# HIGHWAY WORK PROPOSAL

<u>COUNTY</u>	<u>STATE PROJECT</u>	<u>FEDERAL</u>	<u>PROJECT DESCRIPTION</u>	<u>HIGHWAY</u>
Southeast Region Wic	1000-20-71	N/A	Sign Bridge Repair & Replacement 2019; Locations On Stn Per Annual Plan	VAR HWY

Addendum No. 02  
ID 1000-20-71  
Revised Sheet 28  
June 4, 2019

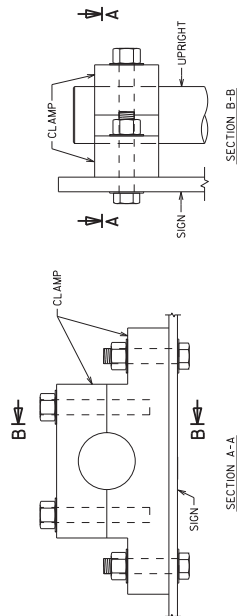
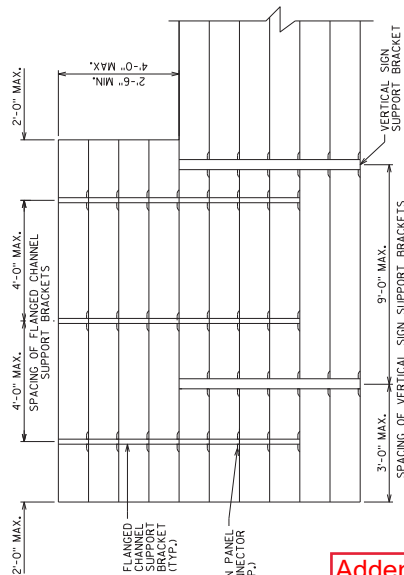
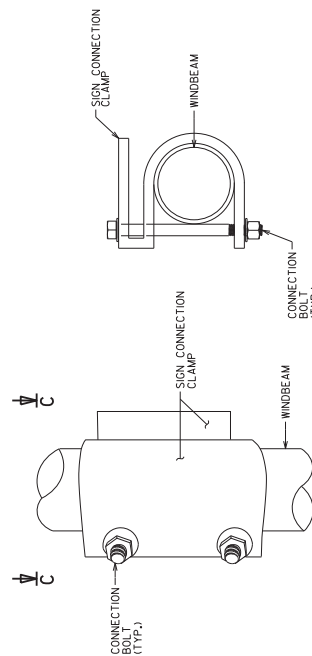
NO.	DATE	REVISION	BY
1	5-31-19	UPDATE BID ITEM AND QTY	SAD

Revised Sheet 35

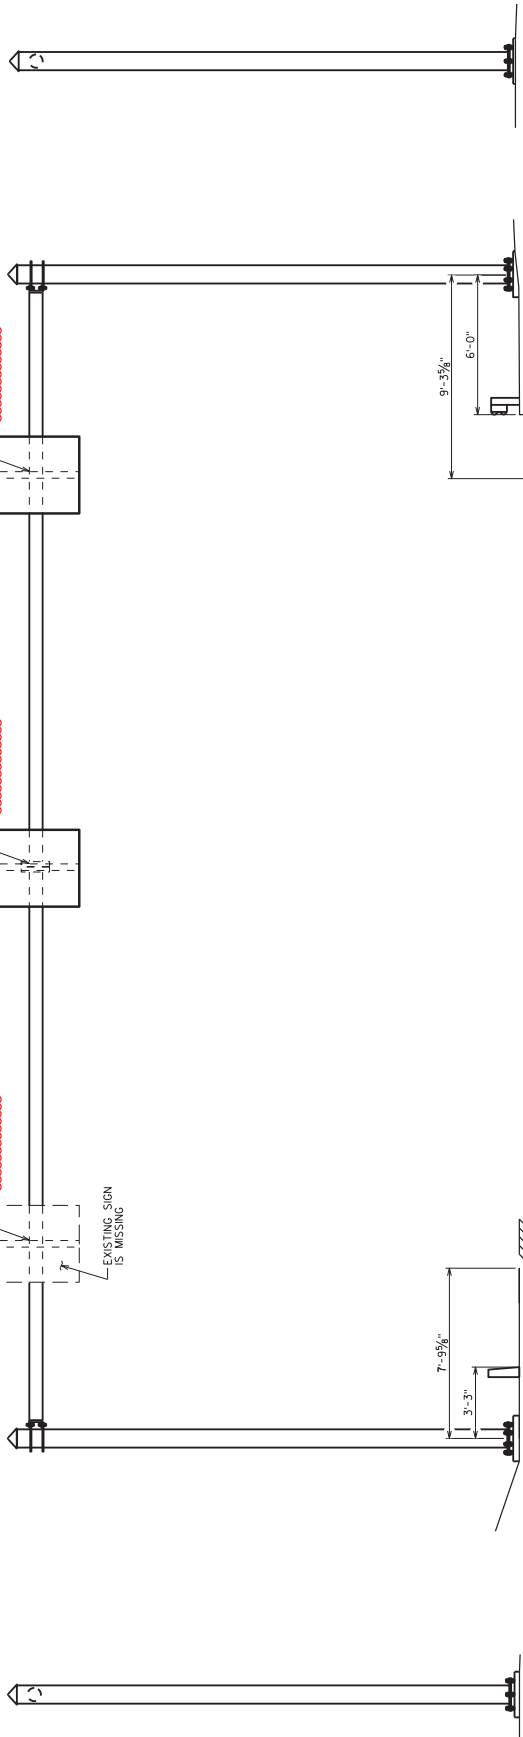
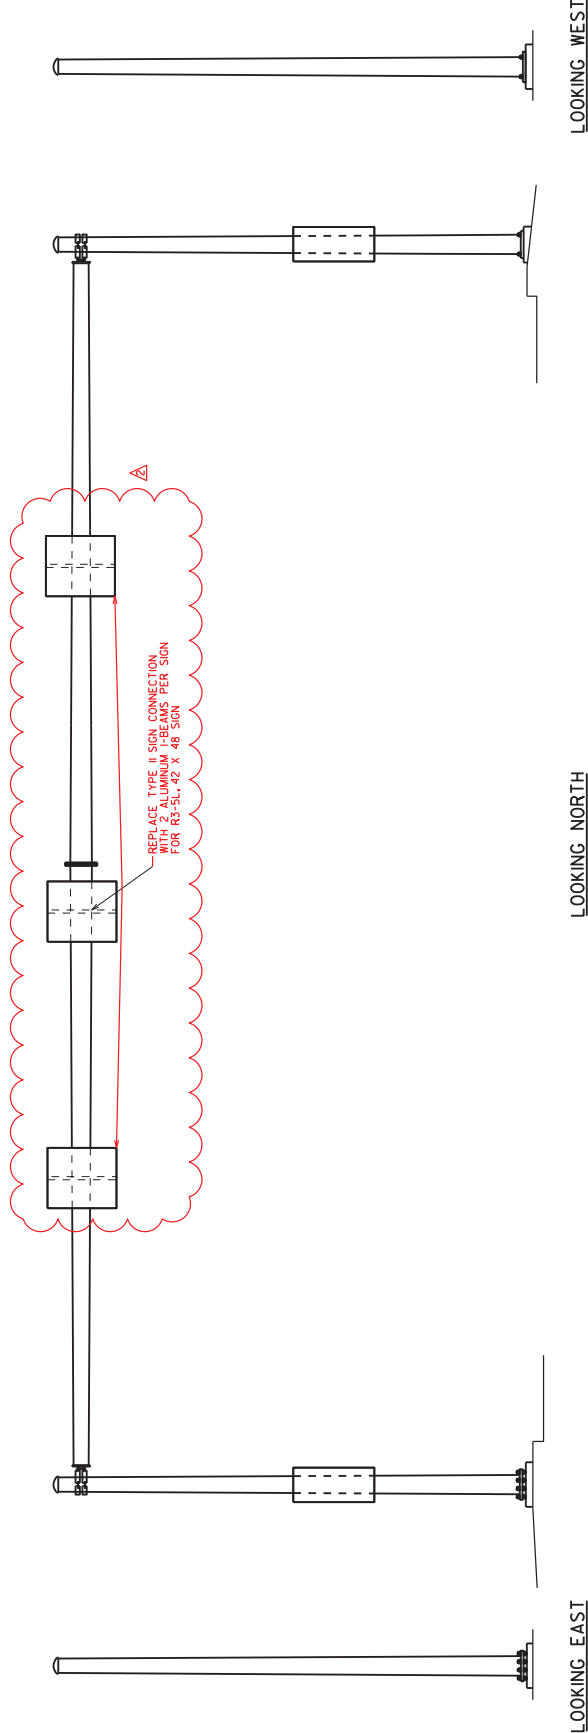
REPLACE SIGN CONNECTION BRACKET WITH 2 ALUMINUM CHANNELS PER SIGN

NO.	DATE	5-31-19	DATE	BID ITEM	QTY	SAD
NO.	DATE			REVISION	BY	
STATE OF WISCONSIN DEPARTMENT OF TRANSPORTATION STRUCTURES DESIGN SECTION						
STRUCTURE SE SIGN REPAIRS						
DESIGNED BY	DRWN	DD	DD	DD	DD	SAD
CHECKED BY	CHKD	DD	DD	DD	DD	SAD
S-30-253						35
SHEET 12

ITEM NUMBER	BID ITEMS	QUANTITY	REPAIR DETAIL SHEET NO.
637.2220	SIGNS TYPE II REFLECTIVE SH	5	5
SPV.00600.14	REPLACE TYPE II SIGN SUPPORT BRACKET WITH ALUMINUM I-BEAM	6 EACH	5

Addendum No. 02  
ID 1000-20-71  
Revised Sheet 51  
June 4, 2019

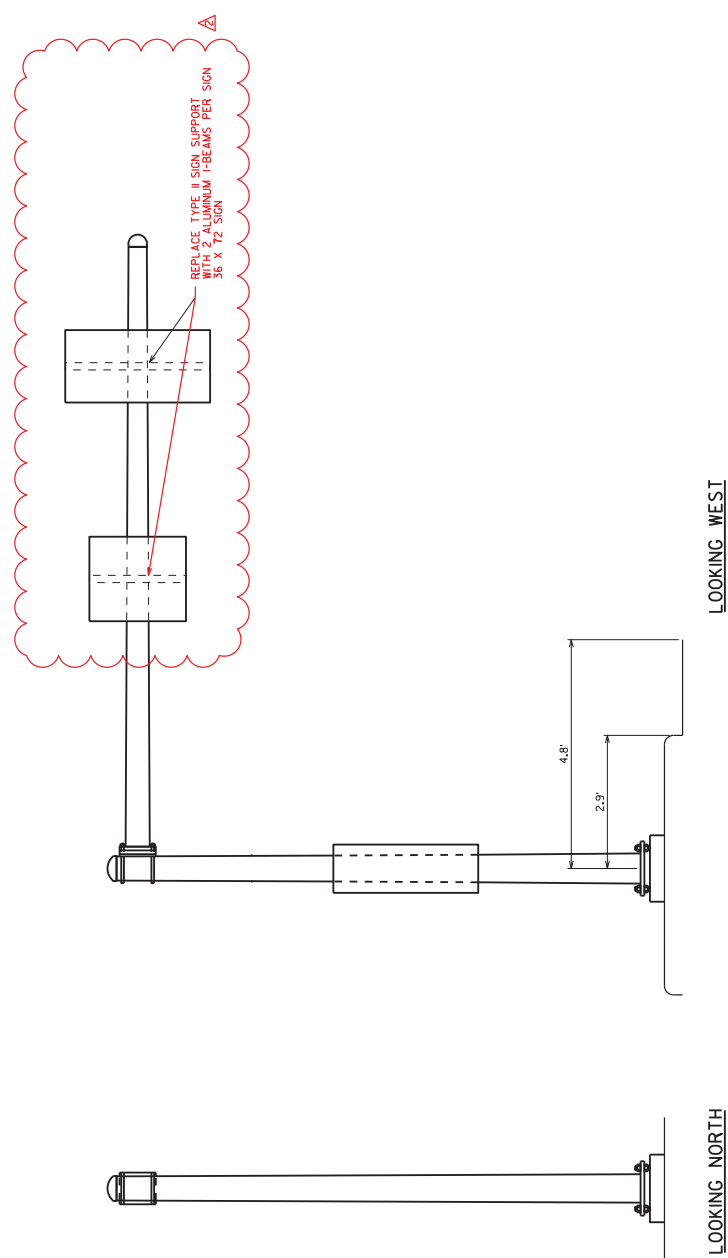
NO.	DATE	5-31-19	DATE	BID ITEM AND QTY	SAD
REVISION	BY				
STATE OF WISCONSIN DEPARTMENT OF TRANSPORTATION STRUCTURES DESIGN SECTION					
STRUCTURE SE SIGN REPAIRS					
BY	DATE	DD	MM	YY	SAD
BY	DATE	DD	MM	YY	SAD
S-40-622					51
SHEET 28

ITEM NUMBER	BID ITEMS	QUANTITY	REPAIR DETAIL SHEET NO.
SPV.0060.14	REPLACE TYPE II SIGN SUPPORT BRACKET WITH ALUMINUM T-BEAM	4 EACH	5

Addendum No. 02  
ID 1000-20-71  
Revised Sheet 57  
June 4, 2019

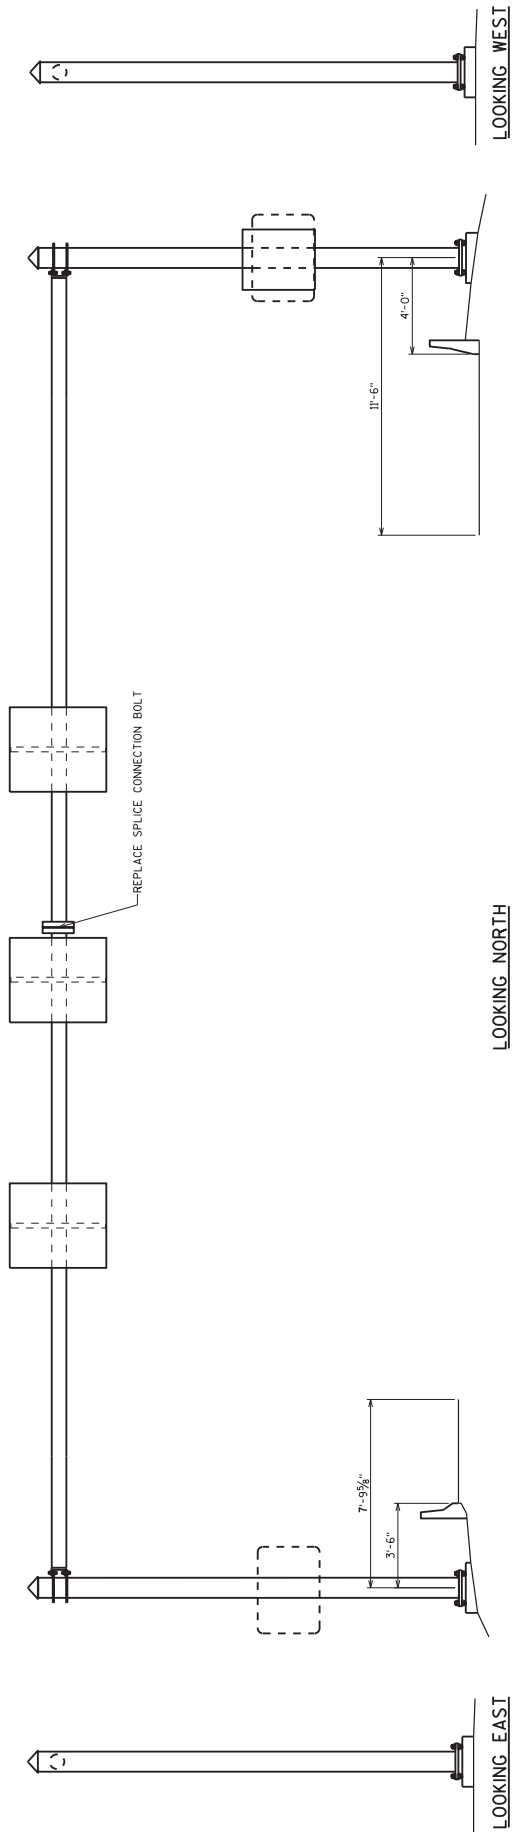
REPLACE TYPE II SIGN CONNECTION  
WITH 2 ALUMINUM I-BEAMS PER SIGN  
R3-5L, 42 X 48 SIGN

Addendum No. 02  
ID 1000-20-71  
Revised Sheet 58  
June 4, 2019

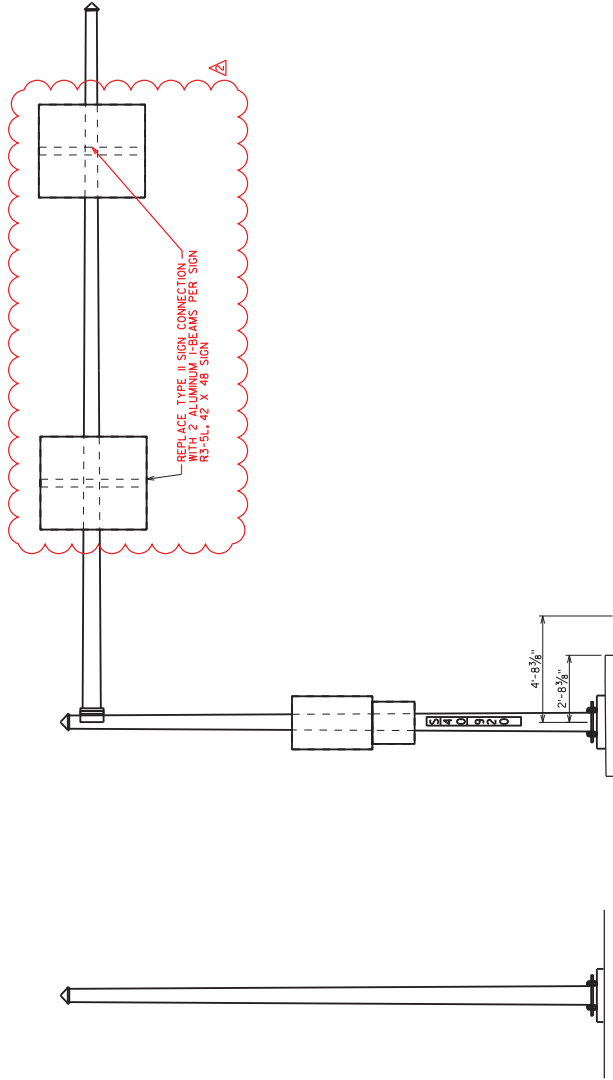
NO.	DATE	REVISION	BY
STATE OF WISCONSIN DEPARTMENT OF TRANSPORTATION STRUCTURES DESIGN SECTION			
STRUCTURE SE SIGN REPAIRS			
		DESIGN	BY
		PLANS	SAD
		DDO	CTD.
			SHEET 35
			58

ITEM NUMBER	BID ITEMS	QUANTITY	REPAIR DETAIL SHEET NO.
SPV.0060.08	TENSION STRUCTURAL CONNECTION BOLT (FRICTION)	6 EACH	3

Addendum No. 02  
ID 1000-20-71  
Revised Sheet 78  
June 4, 2019

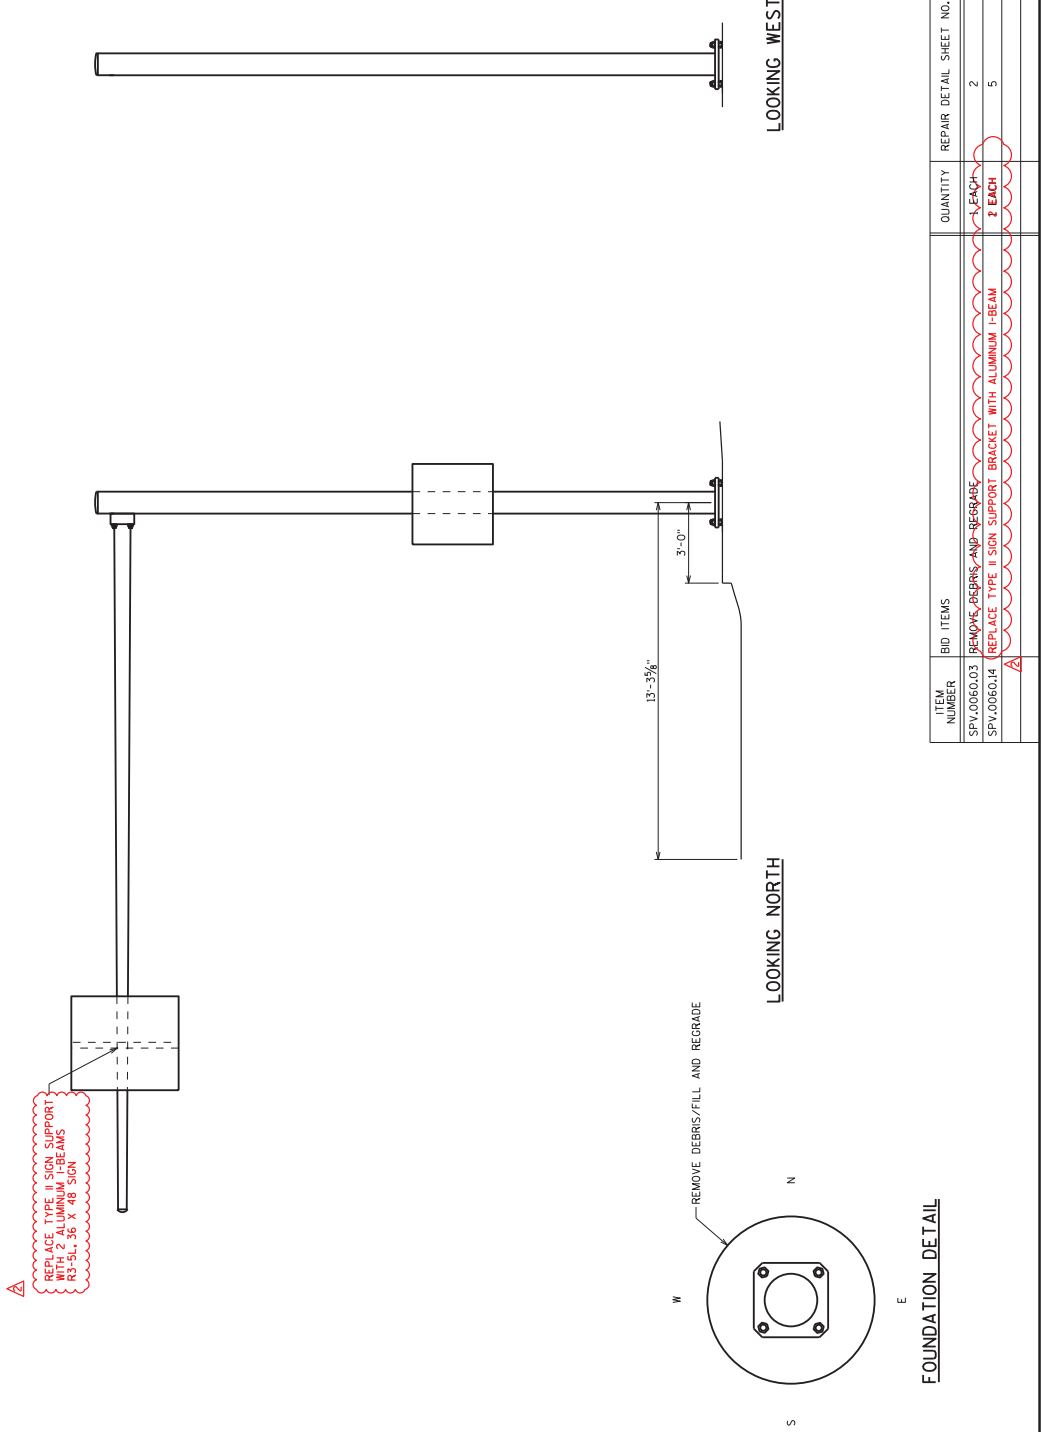
NO.	DATE	5-31-19	DATE	BID ITEM	QTY	SAD	BY
STATE OF WISCONSIN DEPARTMENT OF TRANSPORTATION STRUCTURES DESIGN SECTION							
STRUCTURE				SE SIGN REPAIRS			
ITEM NUMBER	BID ITEMS	QUANTITY	REPAIR DETAIL SHEET NO.	BY	DATE	PLANS	SAD
SPV.0060.14	REPLACE TYPE II SIGN SUPPORT BRACKET WITH ALUMINUM I-BEAM	4 EACH	5				
				DESIGNED			
				CHECKED			
				APPROVED			
				SHEET 55			
				S-67-228			78
